YARRABILBA RETAIL DEVELOPMENT

Lot 13 Yarrabilba Drive, Yarrabilba

PLANS AND DOCUMENTS
referred to in the PDA
DEVELOPMENT APPROVAL

Approval no: DEV2022/1316

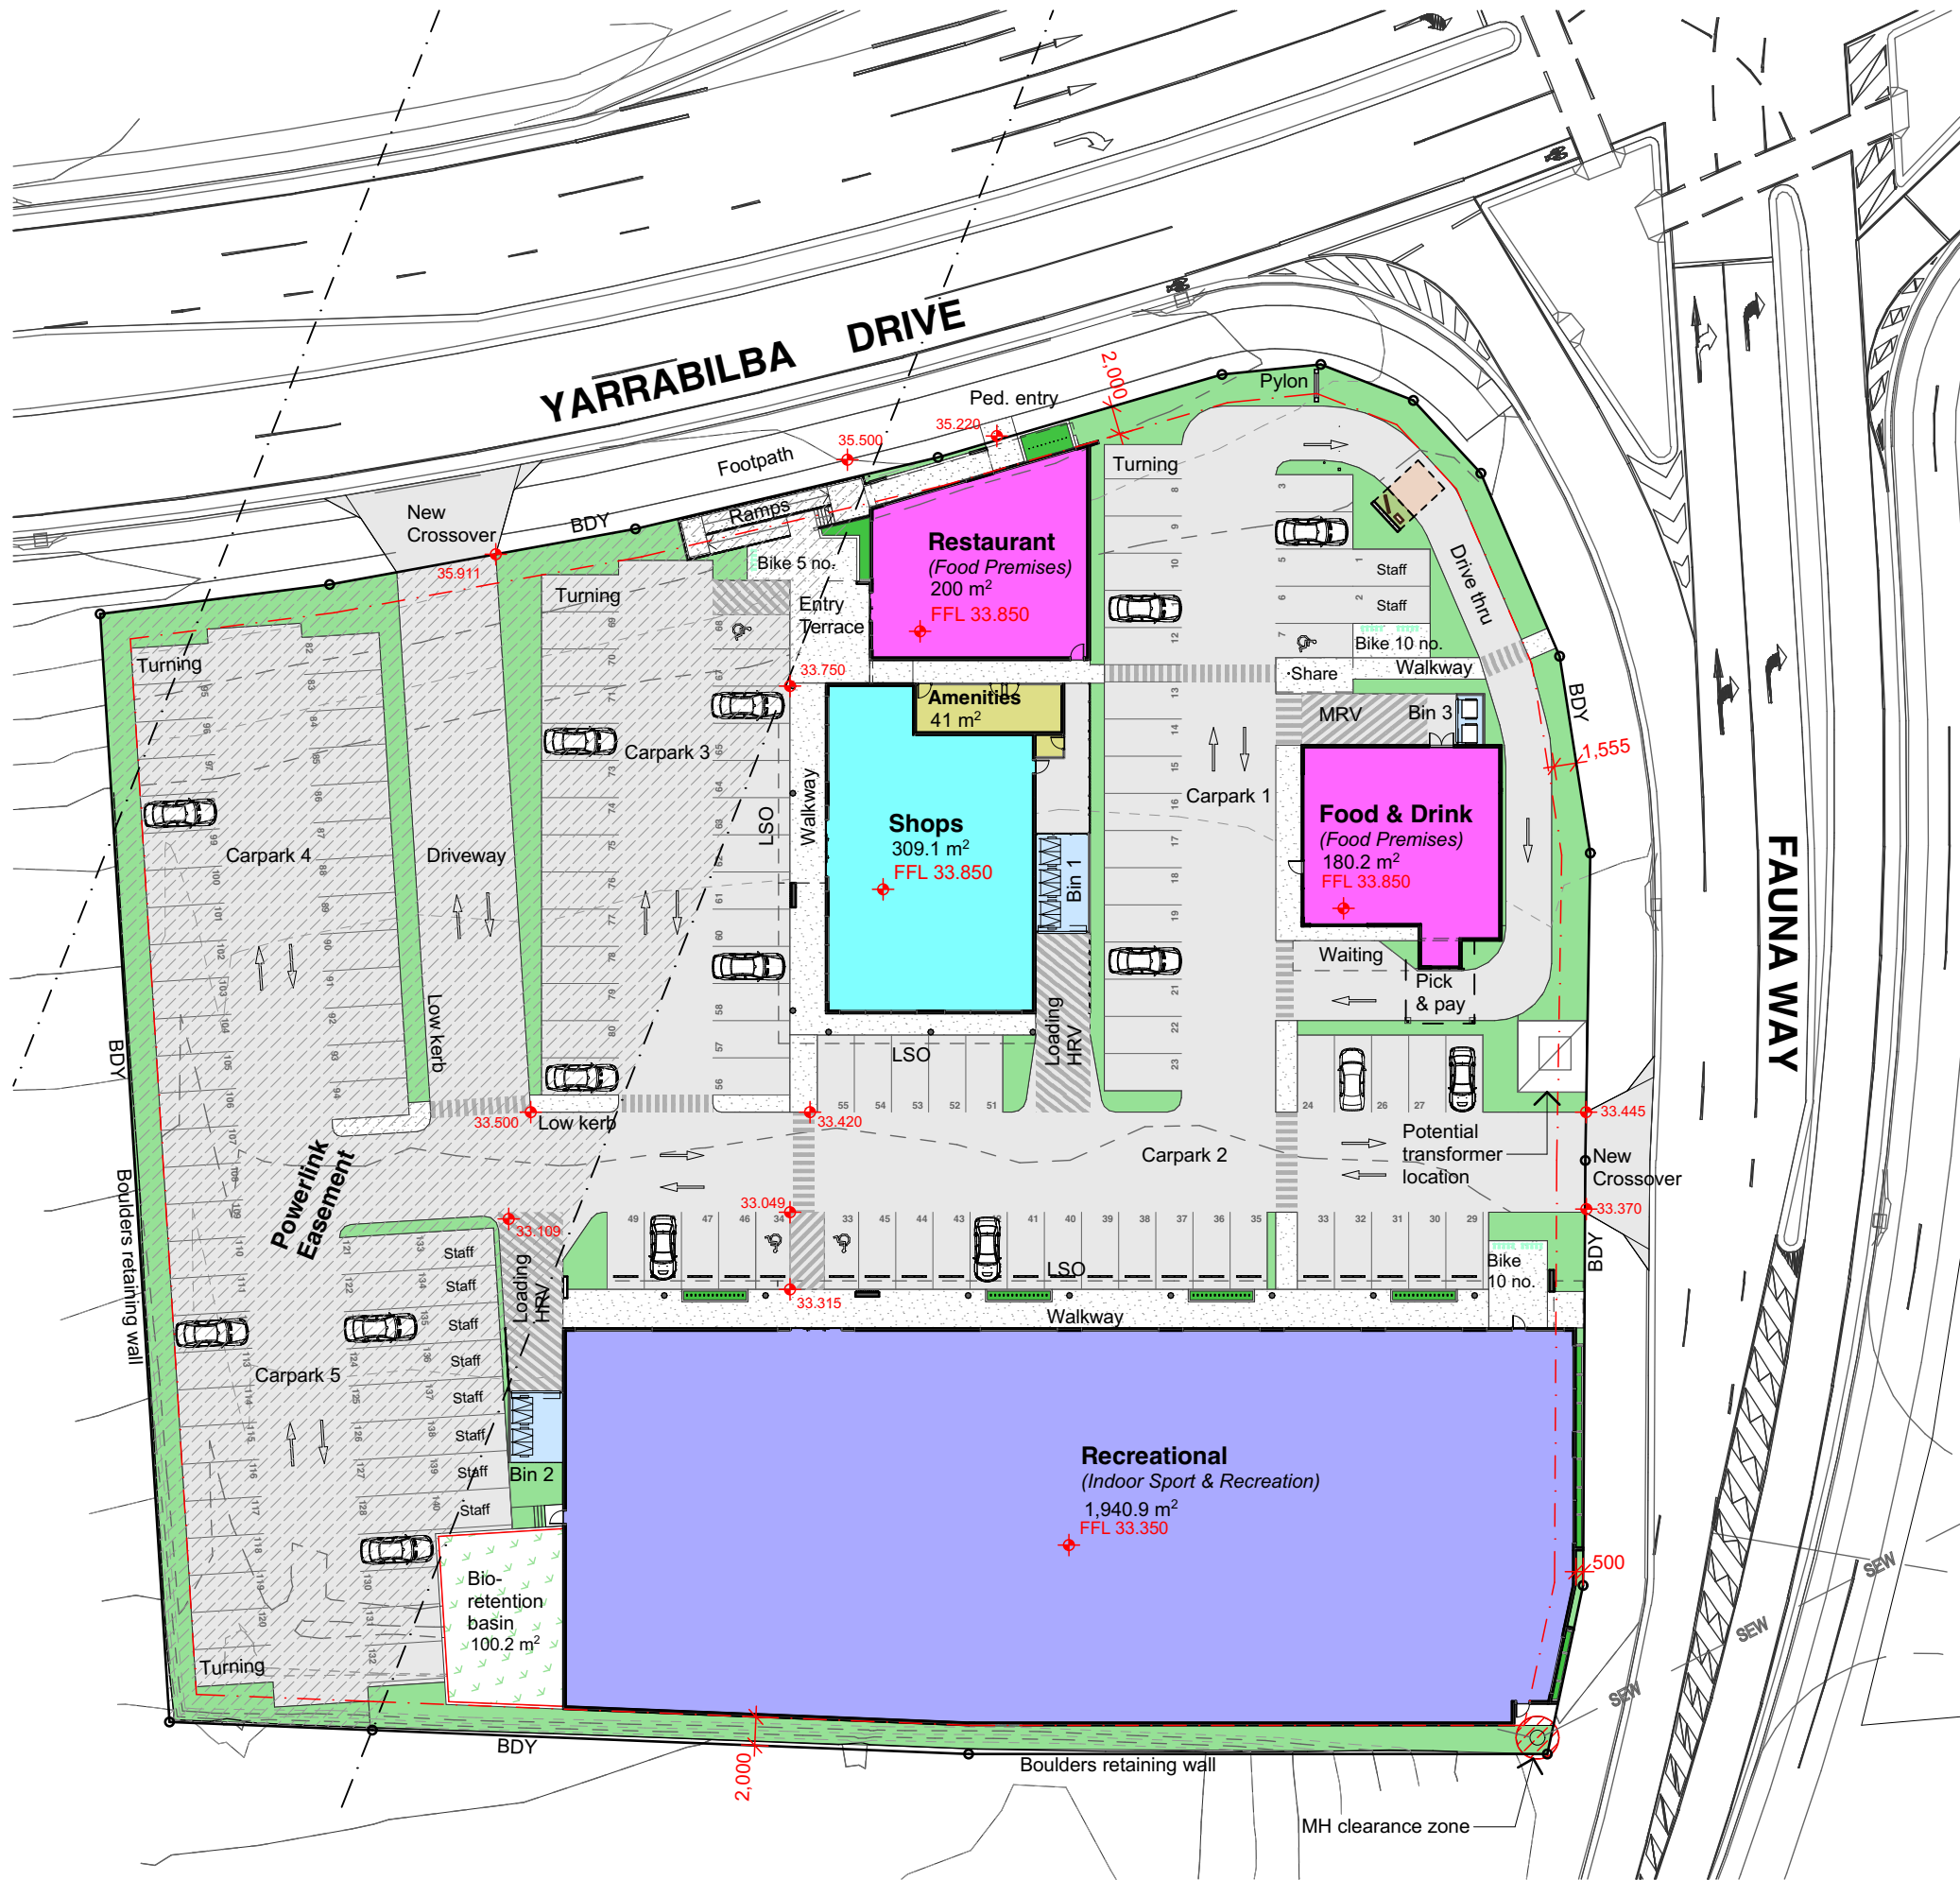
KERBING TO BE DESIGNED TO ALLOW FOR UNOBSTRUCTED ON-SITE MANOEUVRING OF HEAVY VEHICLES. REFER TO TRAFFIC ENGINEERING ASSESSMENT REPORT PREPARED BY PTT TRAFFIC AND TRANSPORT ENGINEERING, DATED 20 OCTOBER 2022
